## Memorandum

To: Planning Commission Members  
From: Elizabeth J Corwin, PE, AIPC; Planning Director  
Date: November 6, 2025  
Re: SPR25- 01  
Applicant: Steve Kolber/Kolbrook Design. Owner: OM Group  
140 W Highland Road  
PIN 11-22-301-007

To: Planning Commission Members  
From: Elizabeth J Corwin, PE, AICP; Planning Director  
Date: October 16, 2025  
Re: Special Land Use Approval and Site Plan Review for Jimmy John's and Dunkin'

Re: Site Plan Review 3  
Jimmy John's/Dunkin  
140 Highland Road  
Sidwell No. 11-22-301-007

**1 SCHEMATIC SITE PLAN**  
 SCALE: 1/16" = 1'-0"

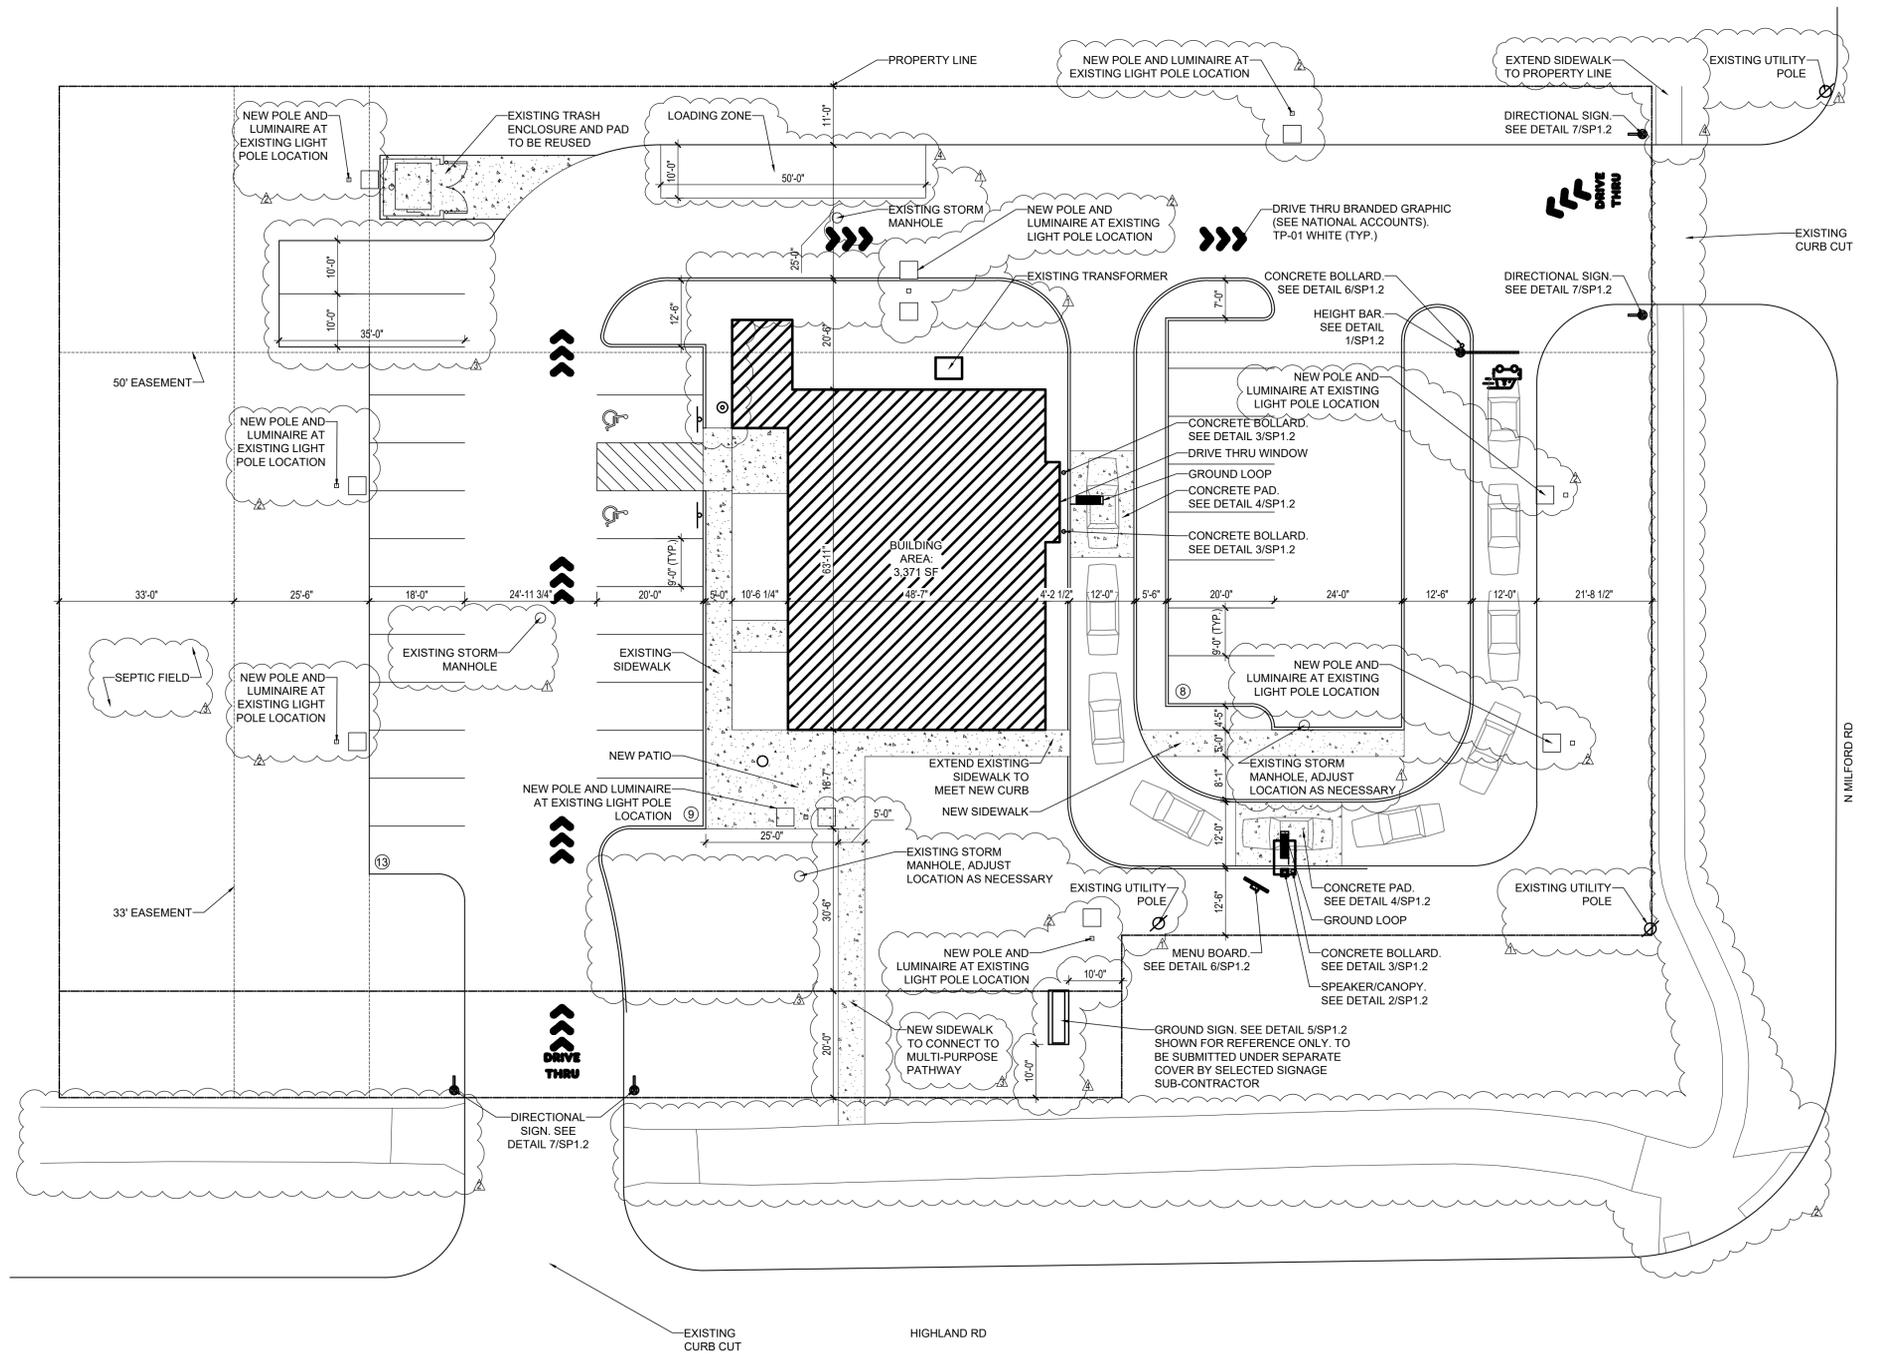
- See SP1.0 showing the parking calculations, the extended sidewalk along Milford Rd to the cemetery, the proposed ground sign moved to be located 10' from the ROW in both directions, and a designated loading/unloading zone.

The plan should include a table of basic site data, including the parking calculations. In general, the requirement for a restaurant is one space per 70 square feet of the net floor area of the restaurant, plus 10 stacking spaces plus two longer spaces for recreational vehicles, buses or semi-trucks (Sect 11.02, Table 11.1). The definition of net area can be found in Section 2.07. If we assume the net area is approximately 80 percent of the gross floor area, the parking requirement would be 38 spaces plus the ten stacking and two longer spaces. 30 spaces are provided, but the two "longer spaces" are impractical, requiring a backing maneuver near the entrance to the site. This does not include any allowance for use of the basement. Additional parking would be required for any use of the basement, even warehousing.

You will note there are discrepancies between the architect's plans and the civil plan. Where there are conflicts, you should defer to the civil plan, which is based on an actual survey. The Milford Road sidewalk currently ends at the driveway and should be extended north to the property line. The Planning Commission should also discuss whether there is enough probability of foot traffic from Milford Road to require an internal sidewalk from Milford Road to the building.

The site plan indicates a proposed ground mounted sign along the Highland Road frontage. The existing ground sign will be reviewed and replaced. The new sign should be located at least 10 feet from the ROW in both directions. (Section 14.07, Table 14.2.)

## 1 PHOTOMETRIC PLAN

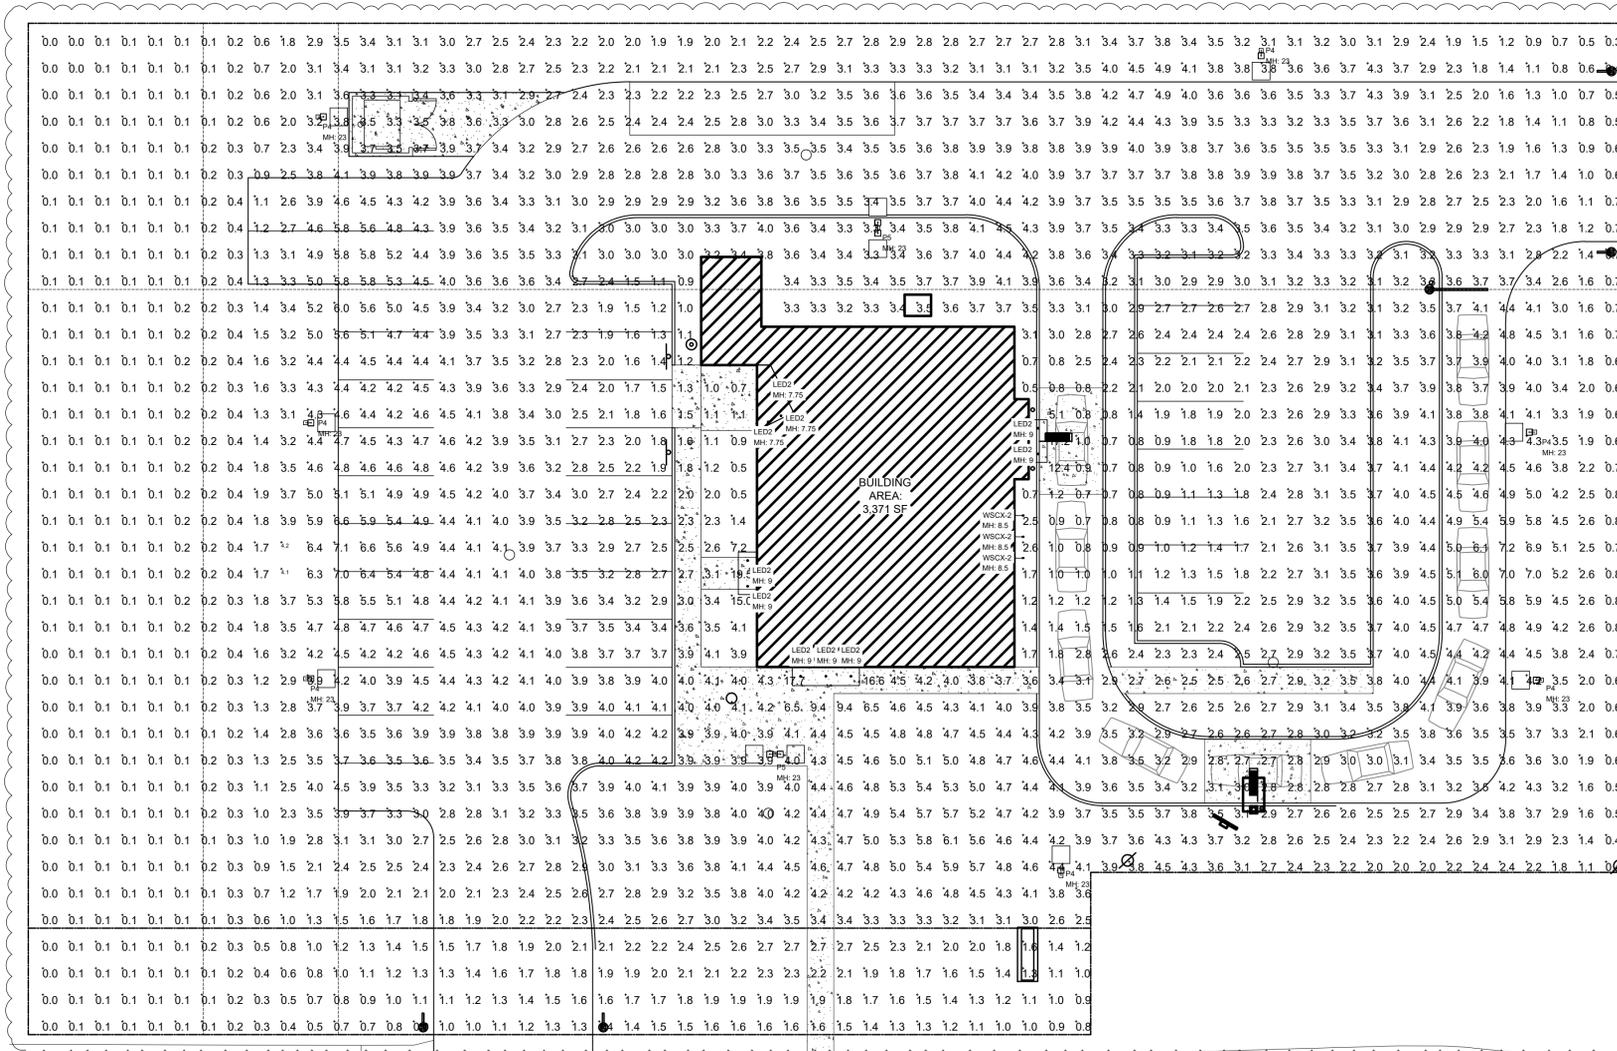
First, the lighting levels at the property line shall be no more than 1 foot candle. They have chosen pole mounting heights that are compliant and are essentially in the same locations as the existing site lighting. They may have to consider alternate models with a lesser impact in order to achieve the target lighting levels. They have noted on the drawings that the lighting levels will be reduced after 11:00 p.m. to comply with the zoning ordinance.

***Lighting:*** The lighting plan should include "catalog cuts" of the fixtures so as to demonstrate that the chosen fixtures conform to the zoning ordinance, particularly that they are fully shielded and cutoff. The lighting levels through the east 1/3 of the site appear to exceed ordinance limits. The Planning Commission should discuss lighting levels after 11:00 p.m. since the ordinance would typically require reduced lighting levels.

- See PH1.1 and PH1.2 for the lighting cut sheets and the added General Note D on PH1.0 about the light levels after 11 pm.
- See L1.0 showing how the planting will be bedded and added Landscaping Maintenance note. Also, there are existing faucets on the front and back of the building that will be maintained and used for providing a readily available water supply per Section 12.03.B.6.c.

**PROPOSED EXTERIOR ELEVATIONS**

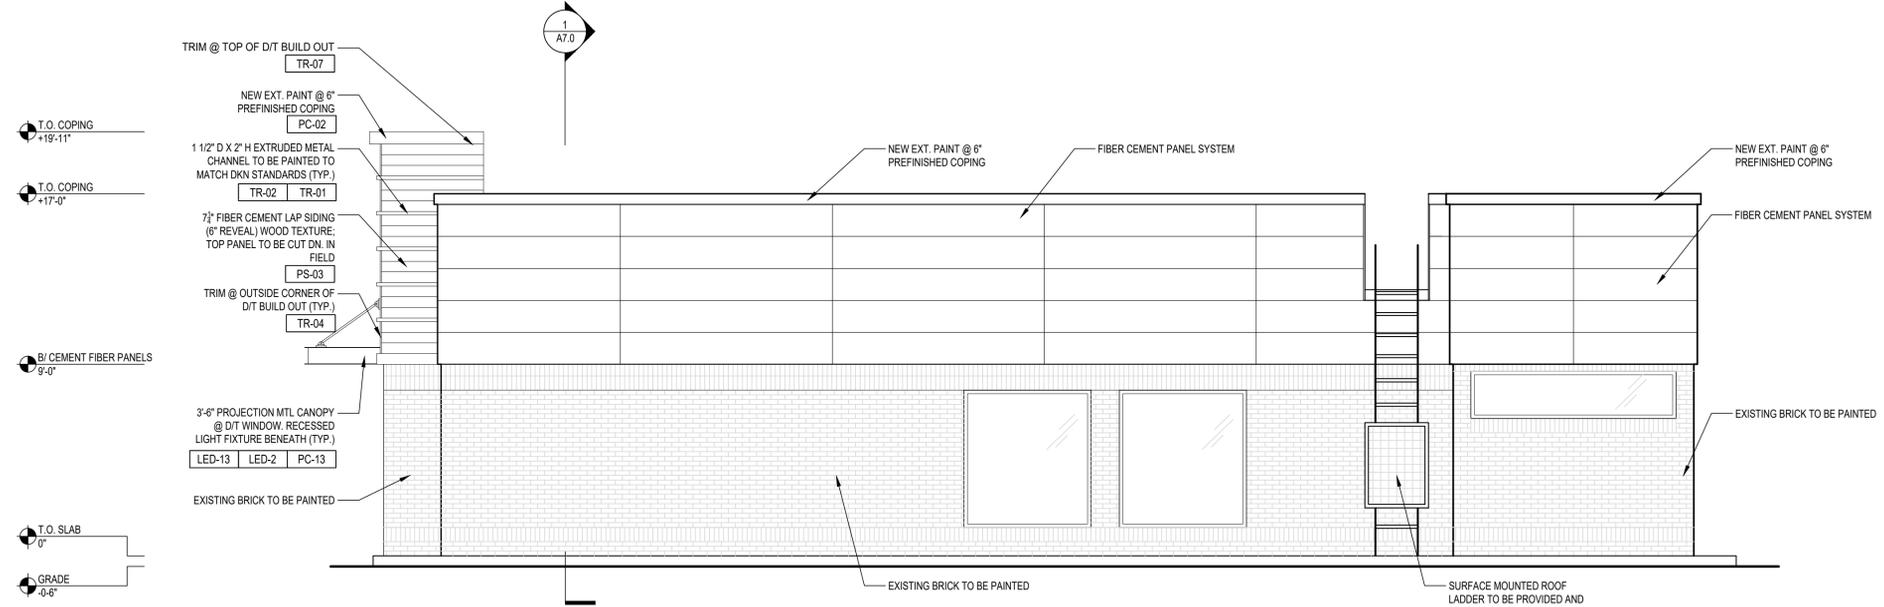
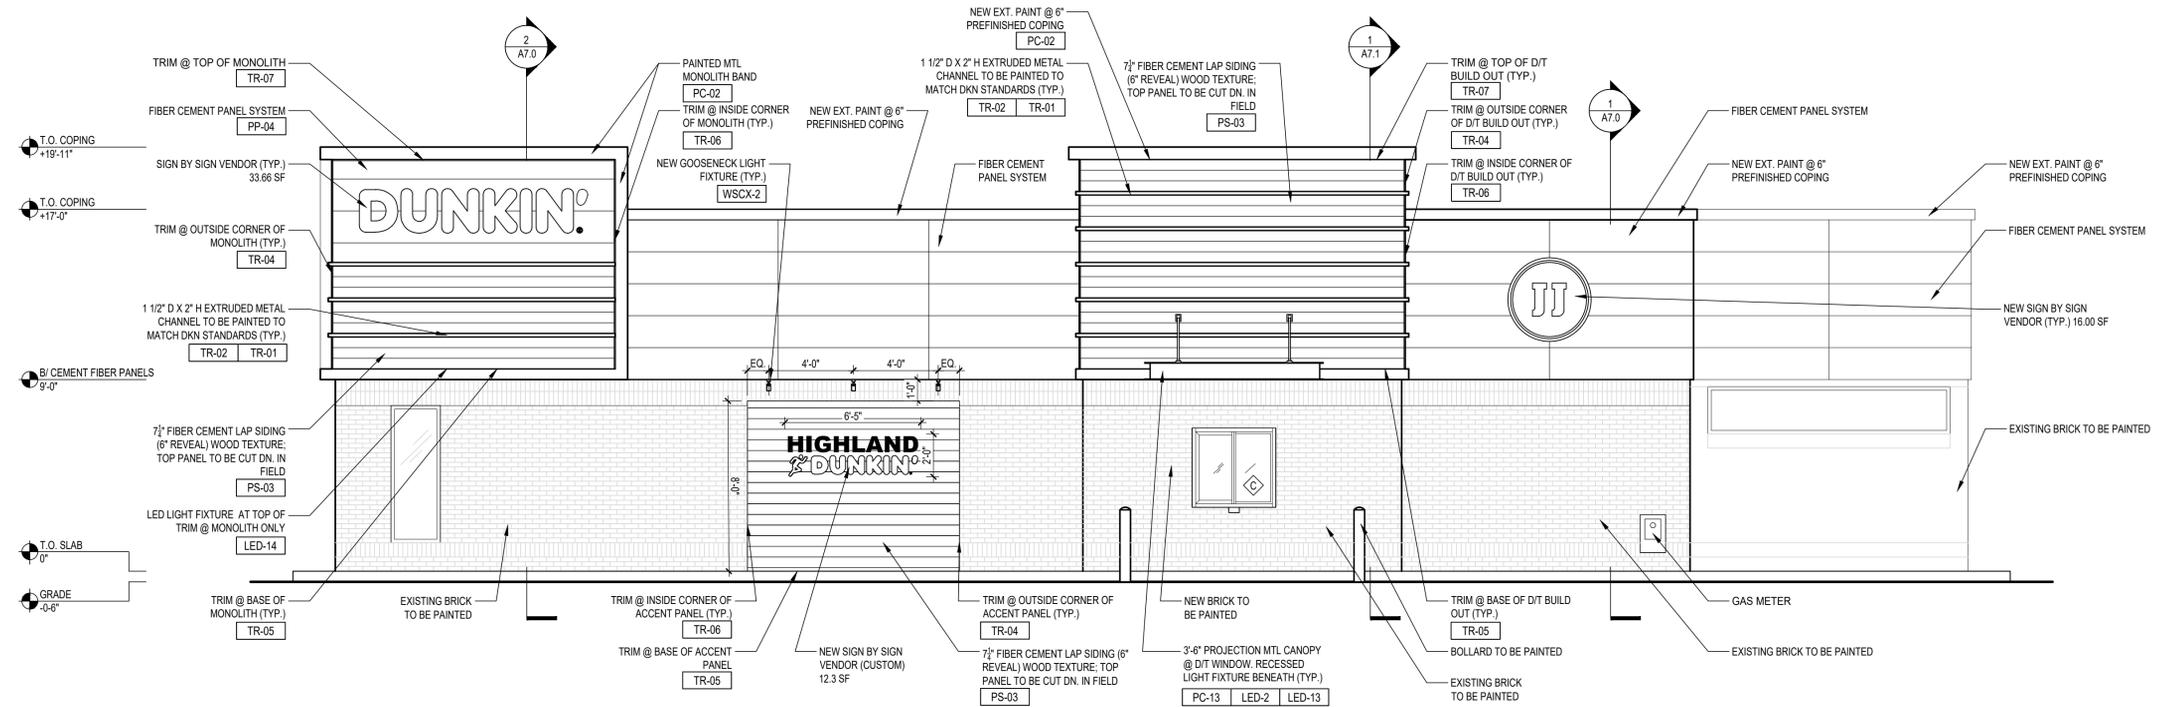
The second issue is that the signing package greatly exceeds ordinance limits. They are working with the client to reduce the signage and may seek variances. Your approval, if any, should note that the signage must comply with ordinance limitations or variances must be obtained.

As for the building mounted signage, the sign allowance is 2 square feet for every lineal foot of the primary façade (2 sq ft x 47 lf = 94 sq ft). This signage may be split on multiple faces of the building. While I have not independently verified the calculations indicated on the site plan, there are signs on 3 faces of the building totally 193 square feet. No new building façade plans have been submitted since April, so it is unclear how the applicant intends to comply with the ordinance. While the Planning Commission may allow the signage to be split on multiple faces of the building (Sect. 14.07.J.1) there is no provision to allow for additional signage. Granting additional signage would require approval of a variance by the Zoning Board of Appeals.

- I have included the exterior elevations showing the wall signage as it currently stands. We understand your comment that we are over the allowed amount and will require a variance if we plan to continue with the signage as shown. We are working with the brands to see if we should reduce the signage to meet the ordinance or keep it as is and go for the variance. In the end we want to provide a good amount of signage for each tenant and show equal representation. We will keep you updated as we come to a decision.
